County of San Diego Department of Environmental Health
P.O. Box 129261, San Diego, CA 92112-9261

INSPECTION REPORT

**COUNTY OF SAN DIEGO
DEPARTMENT OF ENVIRONMENTAL HEALTH
PERCOLATION TEST REPORT**

Subject: Wier / Taylor Parcel Map, Penn St., Ramona, CA 92065
A.P.N. 280-124-03

AS built for Septic System 740 ft.

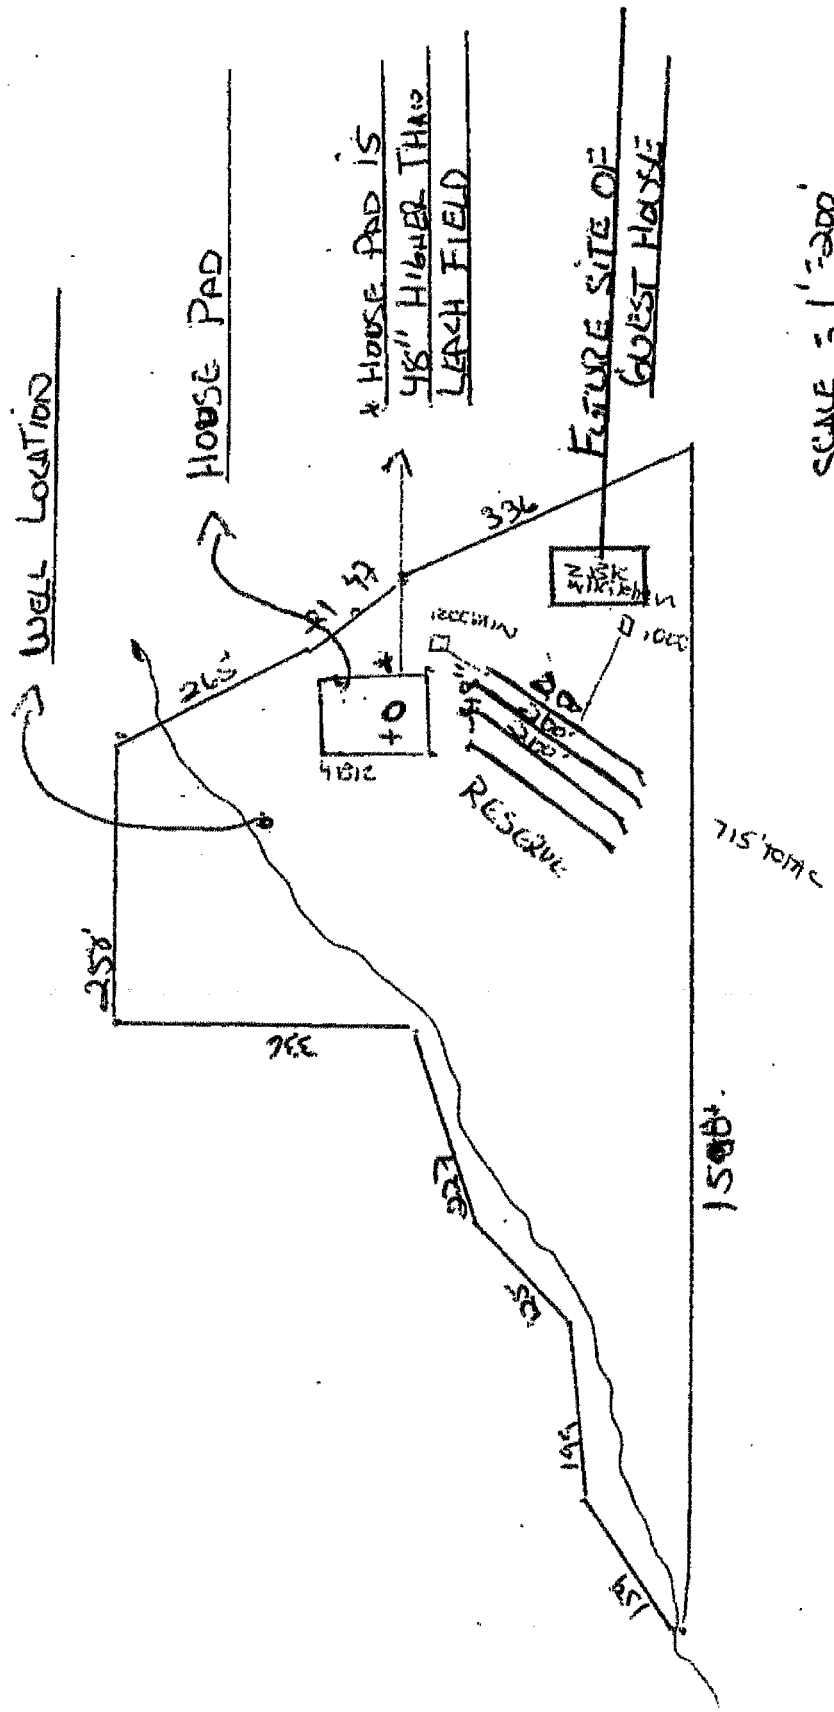
This project is approved with the following conditions noted:

1. ☒ 100' to water well (tank and lines /150' to H-pits/
1/4 mile for V pits).
2. ☐ 100' to high water line or creek or pond.
3. ☐ 5:1 setback to cut bank or slope greater than 60%
(5' horizontal for every 1' vertical up to 100')

7. ☐ Grading limited to design shown, or not to impact
adjacent lot.
8. ☐ Setback to underground utility trenches (5:1).
9. ☒ Maintain required setbacks (paved areas and
driveways require setbacks).
Septic tank to all structures is 5'.
Leach lines to all structures is 8'.
Seepage pit to all structures is 10'.

10. ☐ Slopes exceed 25% (see special conditions).
11. ☒ System to be located in native, undisturbed soil
12. ☒ System to be located in approved, tested area.

13. ☒ Leach lines to follow contour of land.
14. ☒ Plumbing fall to allow standard trench depth.
15. ☒ Trim and remove trees as necessary.
16. ☒ Tank to be installed in native material.

* 1 4BR PRIMARY AND FUTURE 2BR
GUEST

Septic Tank (in gallons): PRIMARY 1200 MIN
GUEST 1000

Leach Line: Length * 710 ft (+100% reserve)

Trench Depth 3' Rock Below Pipe 1'

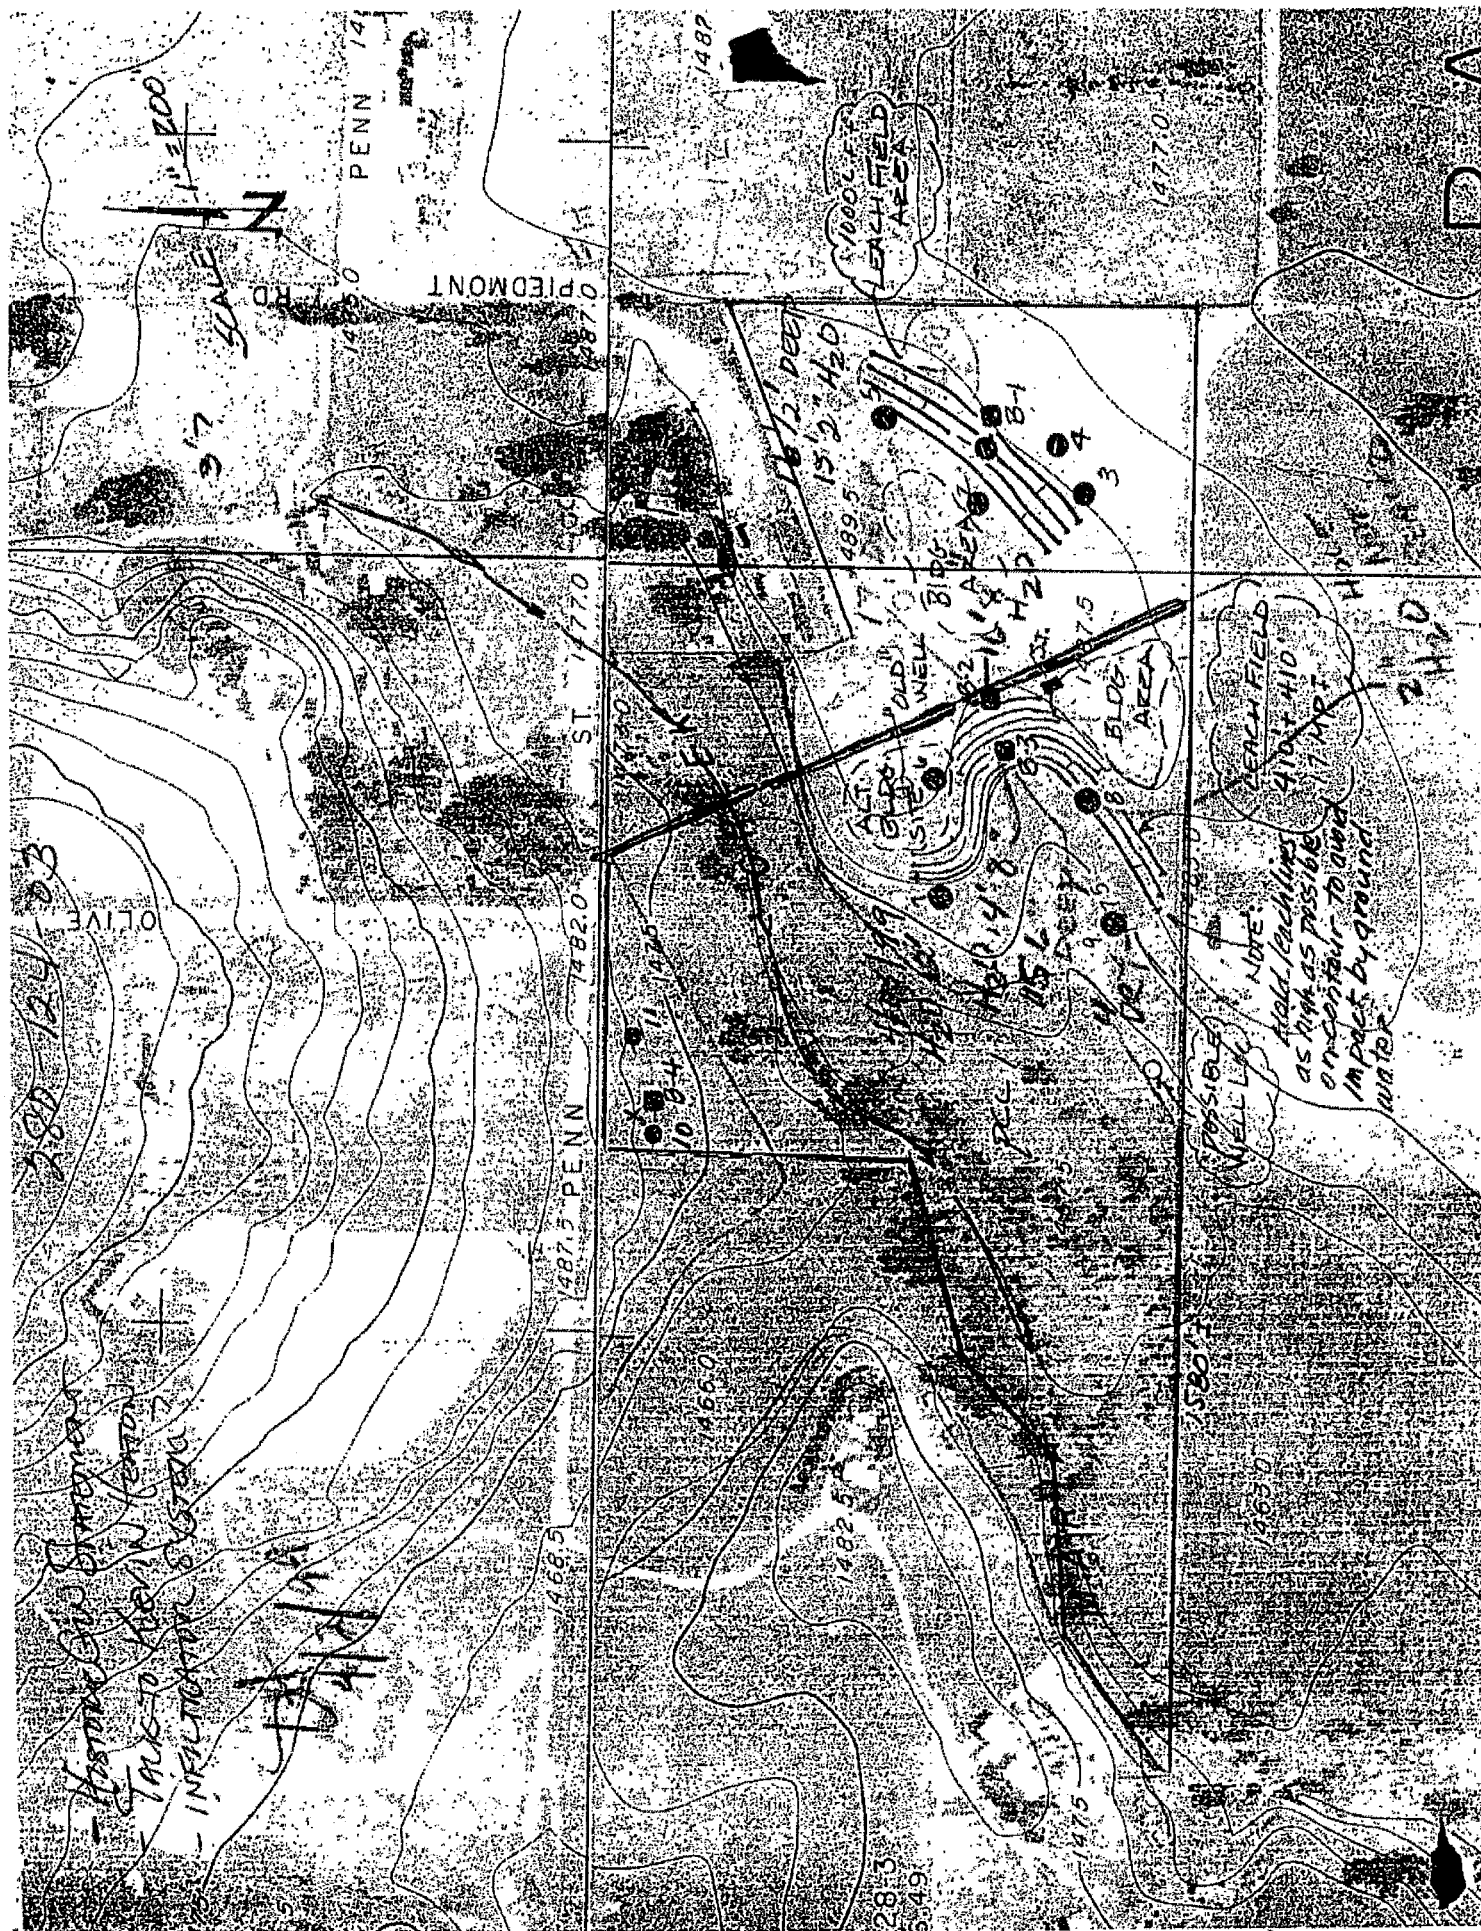
* NORTH SIDE OF CREEK - LEACH LINES NOT
Recommended due to variable clay soil.
2nd Dwelling unit on N-side of Cr. would need
to pump across to 30' SIDE OF CREEK FOR SEPTIC.

* Keep all lines above boring B-3

The septic tank layout on parcel 1 has been revised to show the leach lines as high as possible on contour. Refer to the attached layout for parcel 1. The review of a site specific layout is required prior to the issuance of a septic tank permit to ensure that the leach line location can be reached by gravity flow. A raised foundation or raised pad may be necessary in order to keep the plumbing stub-out from being too deep.

Based on the percolation data and ground water information from the immediate area, it is my opinion that the ground water would not be expected to rise within five feet of the bottom of the proposed leach line trenches during an average rainy season. It is possible, however, that during periods of heavy rainfall, spikes in the ground water may cause the ground water to encroach on the required separation, typically for a short duration.
